West Gate Tunnel Project IAC

## **West Gate Tunnel Project**

**Submission on behalf of Maribyrnong City Council**

**WEST GATE TUNNEL  
ENVIRONMENT EFFECTS STATEMENT  
SUBMISSION ON BEHALF OF MARIBYRNONG CITY COUNCIL**

Figure 1: Paramount Road corridor zoning – area shaded green denotes the 'Paramount Road corridor'

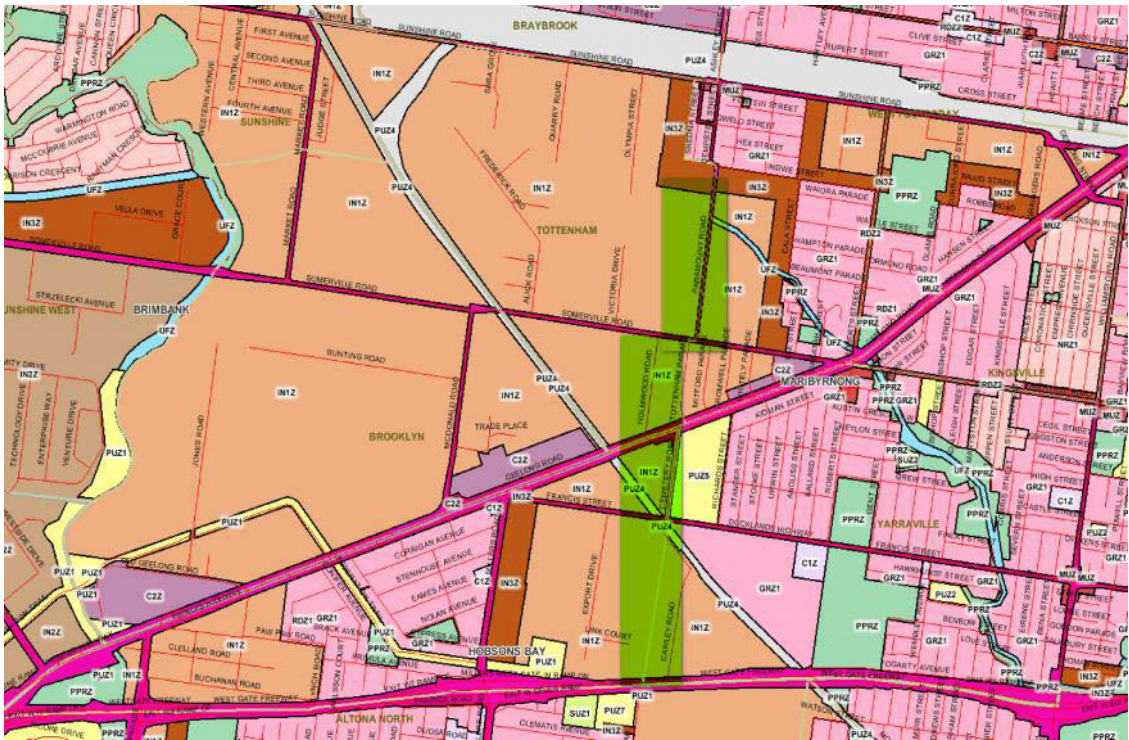
- 2.12 As set out in its letter to the Minister for Planning (*see Attachment 2*), Council has for some time advocated the completion of a road connection from Paramount Road in Tottenham to the West Gate Freeway, as an alternative means of access to the Port of Melbourne, so as to take the pressure off Buckley Street and Moore Street in Footscray.
- 2.13 It is important that the government announced the extended curfews just a matter of weeks after that letter was sent to the Minister for Planning, because there had been no commitment to extend curfews to Moore Street and Buckley Street prior to that.
- 2.14 Council recognises that as the government has committed to extend 24 hour curfews to Moore Street and Buckley Street, this necessitates an alternative means of access for freight to and from the Tottenham Industrial Precinct.

Figure 2: PAO reservation for the Paramount Road extension

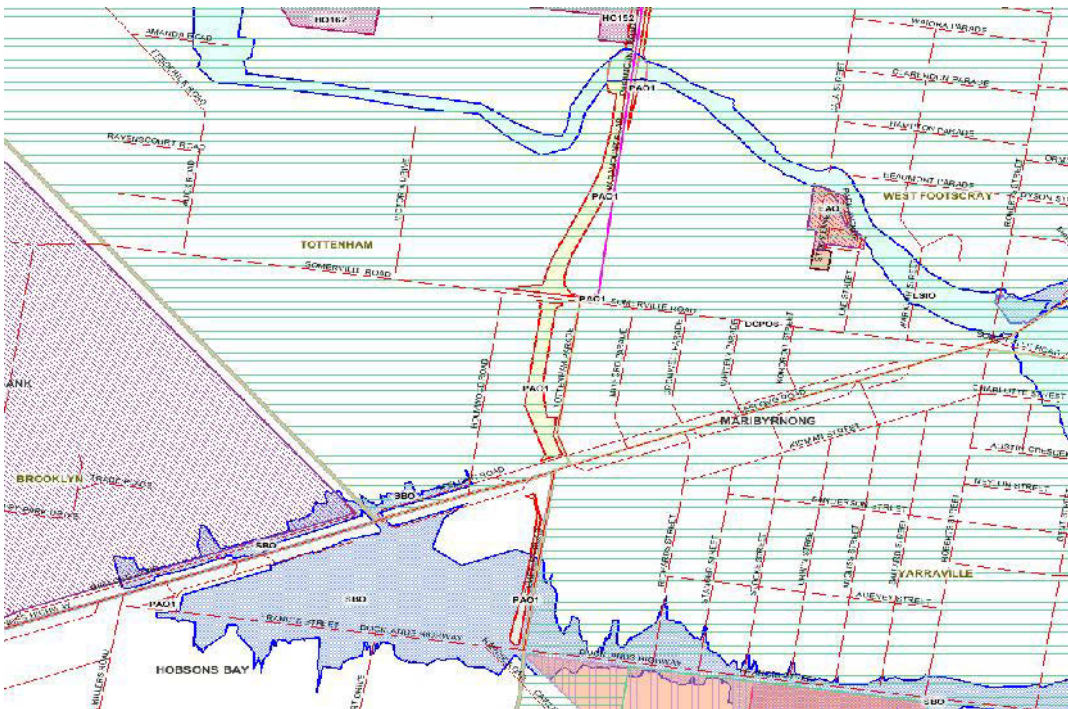
2.15 As can be seen, there is an existing Public Acquisition Overlay over the majority of this corridor, excluding the section south of Docklands Highway.

Figure 72: Truck volumes in Tottenham and Brooklyn: 24-hour period

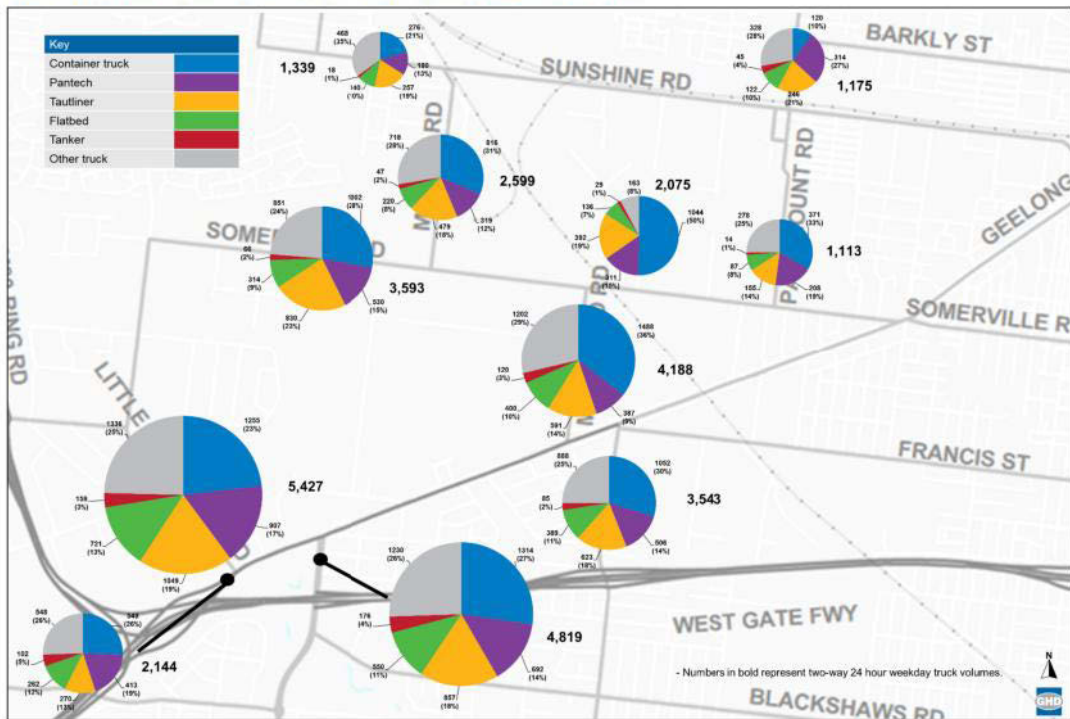
- 2.26 Having regard to Figure 72 of the TIA<sup>5</sup>, it can be seen that Paramount Road carries a relatively small proportion of container truck traffic, compared with McDonalds Road, Little Boundary Road and Millers Road. Seen from this perspective, re-directing that traffic away from Geelong Road should be seen as an important opportunity that may re-direct traffic flows from a relatively small section of the industrial land portfolio.

Figure 58: Freight Industry In Tottenham precinct

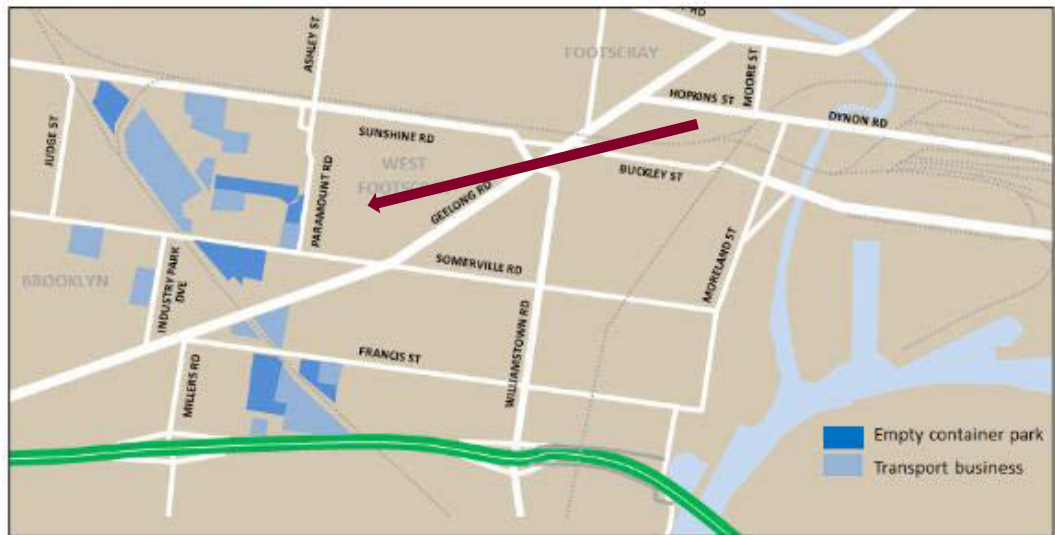
2.27 Figure 58 of the TIA shows that there are no container storage areas to the east of Paramount Road

Figure 15: 2031 project case - AM peak period (7 am - 9 am) volumes - Footscray Road corridor

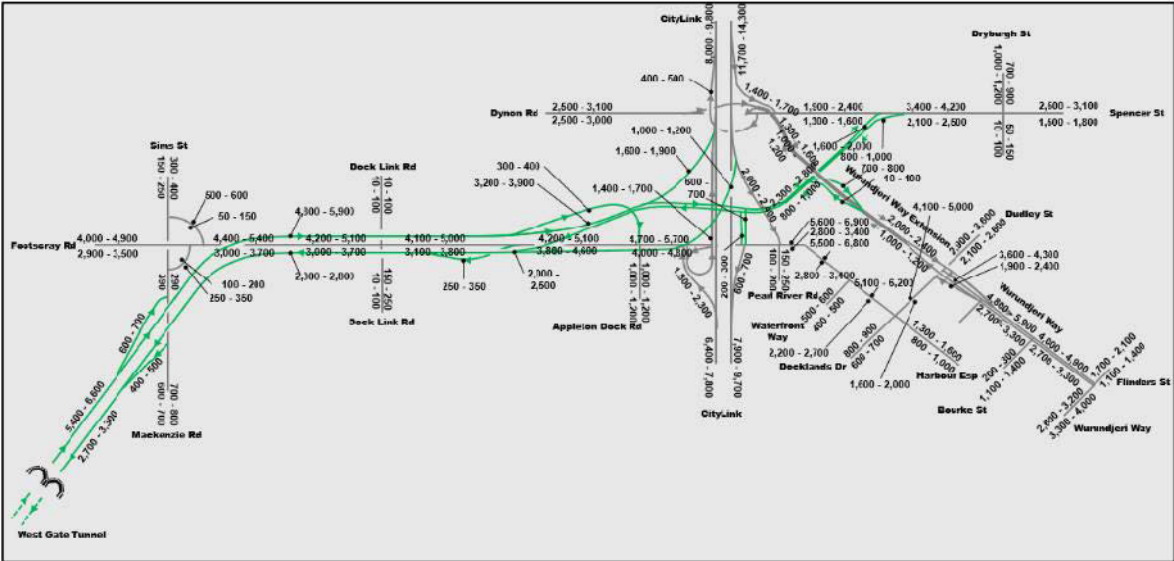
4.13 An apparent error in TIA exists because, in one section of the TIA the entry ramp to Appleton Dock Road shows half as many trucks than the off-ramp to Swanson Dock West, which would service a relatively small part of the port<sup>7</sup>. This is not consistent with other parts of the transport model prepared by GHD showing that the off-ramp to McKenzie Road will carry half of the volume of trucks movements (600-700 vehicles in the am peak), compared with Appleton Dock Road (1000-1200 vehicles)<sup>8</sup> – a position that is logical given the smaller area of Swanson Dock West. Surely a peak demand at those levels can be accommodated without the need for the off-ramp, and also assuming some potential for increased use of rail freight if Swanson Dock is redeveloped.

**Figure 216: 2031 no project vs project case: Hyde Street and Francis Street changes in truck volumes**

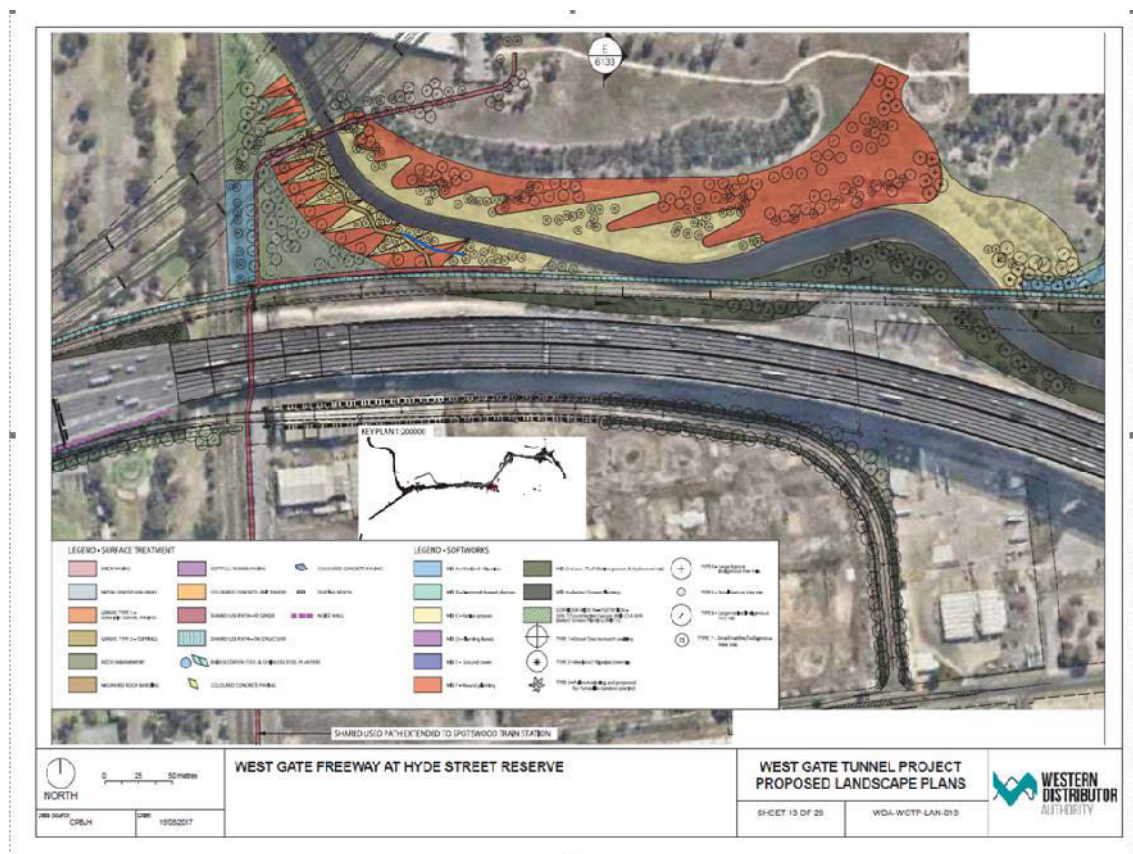
6.47 The eastbound off-ramp to Hyde Street avoids the need for trucks to travel east along Francis Street. The truck volumes using the proposed off-ramp are 1500 – 1900 movements per day for both the on and off-ramp.<sup>23</sup> There is a trade-off to be made between protecting Francis Street and the impacts associated with the northern ramp on the Stony Creek environs, and increased use of Hyde Street. Residents along Hyde Street south of Francis Street are naturally concerned about the modelled increase in truck use along Hyde Street, and some have campaigned for their land to be acquired. The increase in truck traffic along Hyde Street (1200-1600 trucks) is higher than the number of trucks modelled to use the Hyde Street off-ramp (750-950).<sup>24</sup> An assessment of the ability of this intersection to accommodate this level of traffic is required.

6.48 Table 3-3 to the EES includes a comparison of the different ramp options but, it is submitted, there is no clearly explained narrative as to how the different assessment criteria were ranked or weighted.

Figure 21: Yarraville AAQMS PM<sub>10</sub> - June 2012 to September 2013 (24 hour average)

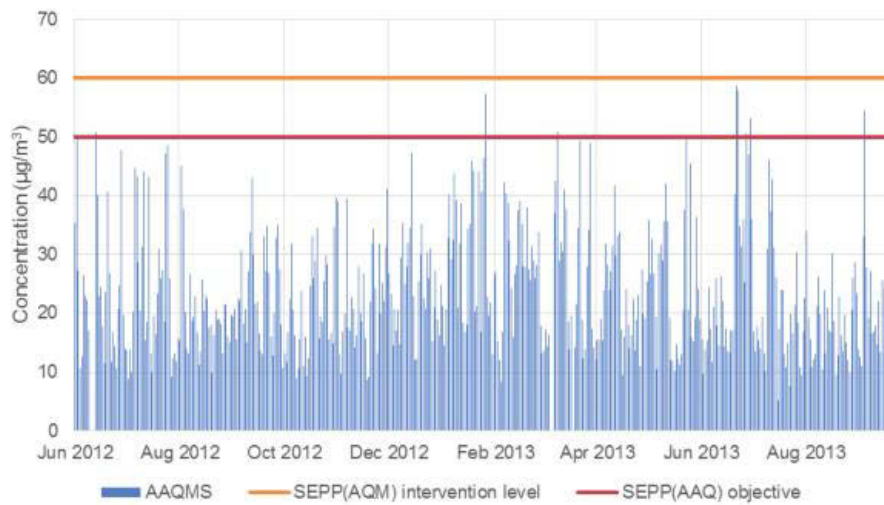
- 10.7 Figure 20-7 drowns out the effects of the WGT project based on assumptions that the background levels at 2031 will be higher, applying a worst case scenario analysis.
- 10.8 What the analysis in Volume 3 fails to do, is to provide a comparison between the current (or 2016) background conditions and the 2031 no project case, to allow the IAC to appreciate the assumed increase in background levels without the WGT. The assumed contribution to background in the no project case needs to be critically assessed.
- 10.9 The following figure, taken from Technical Report G, provides an assessment of the current conditions at Yarraville Gardens (adjacent to the Northern Portal), and provides a basis for comparison with the 2031 figures in Volume 3 of the EES:

10.10 What this shows is that the current levels of particulate matter (**PM**) in the form of PM<sub>10</sub> at Yarraville Gardens are, on average, well below the 50<sub>ug</sub> limit for PM<sub>10</sub> applied in the EES for the 2031 project case. The EES justification, therefore, relies on an assumption that the PM<sub>10</sub> levels will increase from these levels to 59<sub>ug</sub> based on a 24 hour average, but applies a ‘worst case scenario’. The real position is that average PM<sub>10</sub> levels in Yarraville Gardens are well under 50<sub>ug</sub>. There is no analysis to suggest that those levels will increase to 59<sub>ug</sub> on average by 2031 in the no project scenario. If a comparison of the average or median PM<sub>10</sub> levels was used, rather than the worst case result for a 24 hour average, then the AQIA would provide a more meaningful basis for comparison.

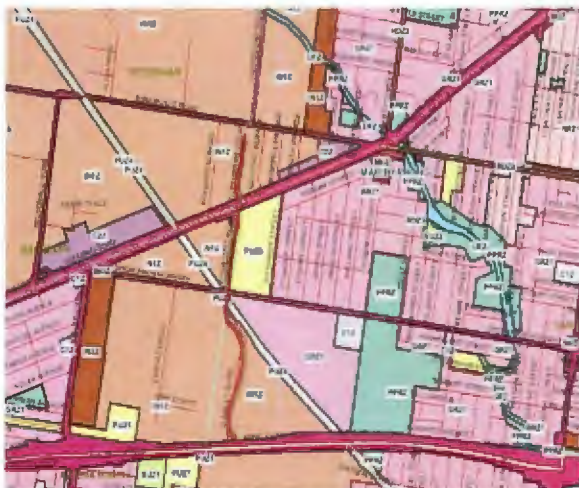
The reference design does not presently include a direct connection from the signalised intersection at Appleton Dock Road and Footscray Road to the Western Distributor. It is unclear whether this is intentional or an unresolved design issue that may be addressed through the bid process.

Council believes that greater integration with the project and this intersection has potential to provide adequate service to the Port and also to minimise adverse environmental effects along the Maribyrnong river environs. At Footscray Road, Appleton Dock Road has an elevated signalised intersection providing two lanes and turning lanes in each direction. It has much greater capacity to absorb growth in freight movements than the proposed ramps over the Maribyrnong River.

It would be a missed opportunity if trucks exiting Appleton Dock Road could not gain direct access to the Western Distributor when turning left from this existing intersection. Similarly, the potential to provide access from Dock Link Road to the new elevated road has not been explored at all to date.
